SUBJECT: Comanche Peak Nuclear Power Plant (CPNPP) Docket Nos. 50-445 And 50-446 Submittal of Requested Information Regarding Fukushima Lessons Learned - Flooding Hazard Reanalysis Report (TAC NOS. MF1099 and MF1100)

Comanche Peak Nuclear Power Plant (CPNPP) Response to Request for Additional Information Regarding Flooding Hazard Reevaluation Report

RAI 1: Local Intense Precipitation and Associated Site Drainage (Choice of Methods and Technical Rationale)

Figure 1: Comparison of temporal rainfall distributions and discharge using the SCS UH Method, without rainfall losses (see note at bottom of Figure 1)

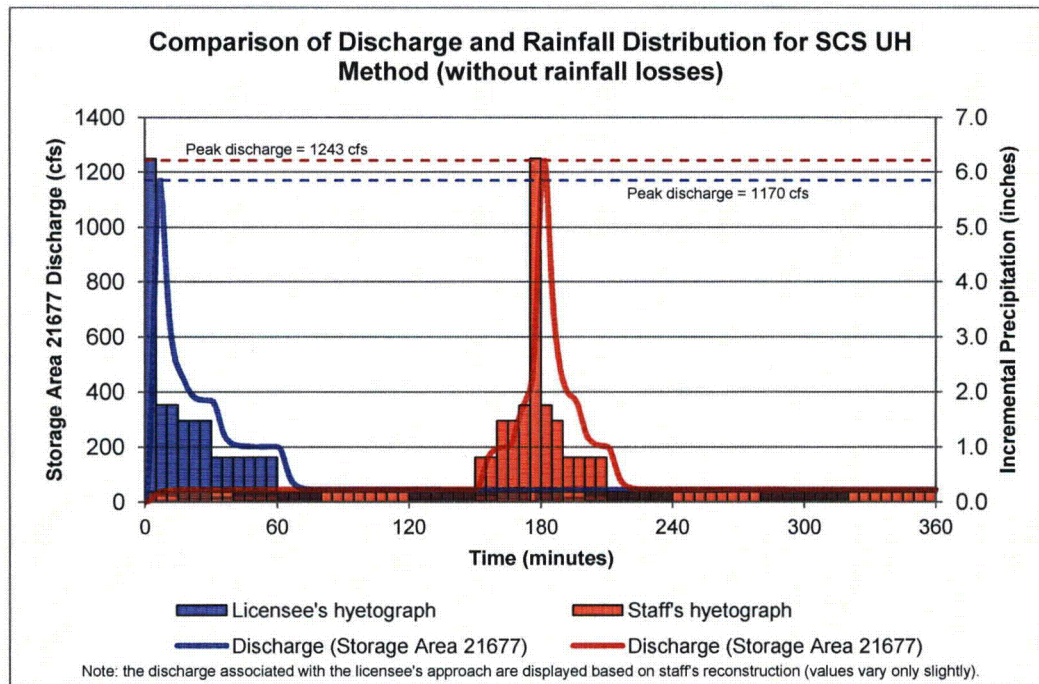
The NRC staff analyzed different temporal rainfall distributions and determined that a centered distribution produces higher peak discharge values compared to a descending distribution for a 6-hour (hr) LIP event. Compared to a descending distribution, the staff's analysis determined that a centered rainfall distribution using the Soil Conservation Service (SCS) Unit Hydrograph (UH) Method without rainfall losses results in 6.2 percent to 6.8 percent higher peak discharge values. An illustration of temporal PMP and discharge values for both distributions is shown on Figure 1 for Storage Area 21677. According to the staff's analysis, for the SCS UH Method including rainfall losses, peak discharge values using a centered distribution, range from 9.3 percent to 23.4 percent, higher than those from a descending distribution. An illustration of temporal PMP and discharge values for both distributions is shown on

Figure 2 for Storage Area 21677. While a centered distribution appears to bound a descending distribution, other arrangements (such as a two-thirds distribution) may produce even higher water levels. Based on the review, the NRC staff requests for the following information:

- A. Technical rationale for assuming a descending distribution for LIP analysis.
- B. Documentation of any sensitivity analysis performed in analyzing the PMP, drainage discharge, and water levels associated with local intense precipitation flooding.

A descending rainfall distribution, with the highest rainfall intensities early in the event, was used in Calculation F-03 (Reference 5) in support of the FHRR in accordance with the method used in Appendix B of NRC NUREG/CR-7046 (Reference 4, Figure B-5).

Sensitivity analyses (beyond the implementation of the Hierarchical Hazard Assessment [HHA] methodology) were not conducted using different rainfall distributions for the LIP analysis.

FIGURE 20-1
FLOOD DURATION OF STORAGE AREA 21669 FOR 6-HOUR PMP, SC4 OF LIP

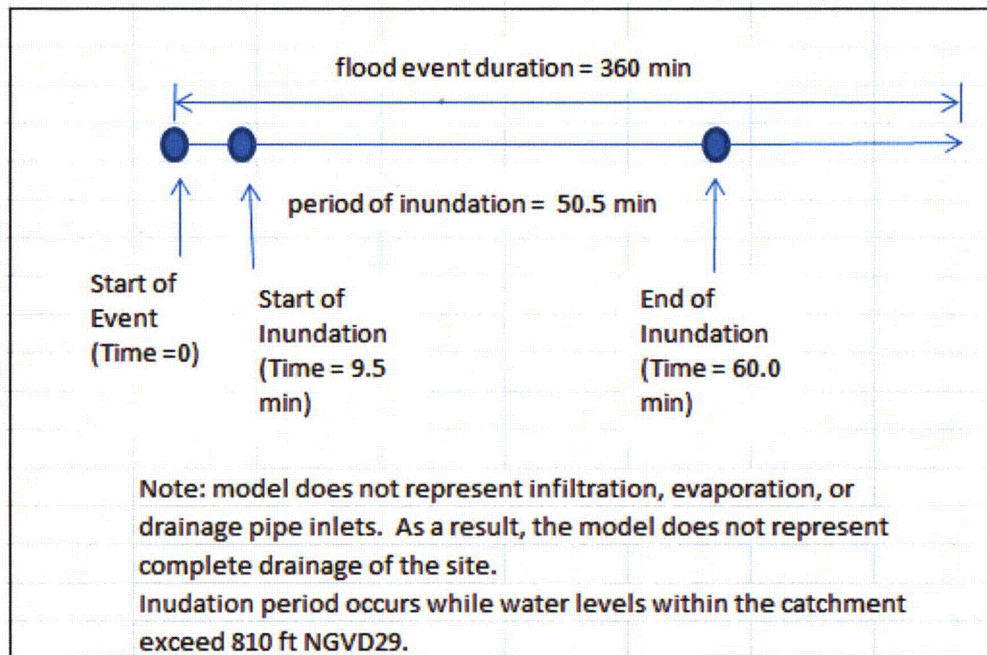
The licensee is requested to provide the applicable flood event duration parameters (see definition and Figure 6 of the Interim Staff Guidance (ISG) JLD-ISG-2012-05, "Performing of an Integrated Assessment," dated November 30, 2012 (ADAMS Accession No. ML 12311A214) associated with mechanisms that trigger an integrated assessment using the results of the flood hazard reevaluation. This includes (as applicable) the warning time the site will have to prepare for the event (e.g., the time between notification of an impending flood event and arrival of floodwaters on site) and the period of time the site is inundated for the mechanisms that are not bounded by the current design basis. Please provide the basis or source of information for the flood event duration, which may include a description of relevant forecasting methods (e.g., products from local, regional, or national weather forecasting centers) and/or timing information derived from the hazard analysis.

Figure 20-1 is provided below in response to RAI 20. A figure is not provided for river flooding (and combined effects) because the plant site grade of 810 ft NGVD29 and applicable safety related SSCs are not inundated by the river flooding event. Figure 20-1 shows the length of time water surface elevations remains above elevation 810 ft NGVD29 for the storage area which leads to the highest water surface elevations around the site.
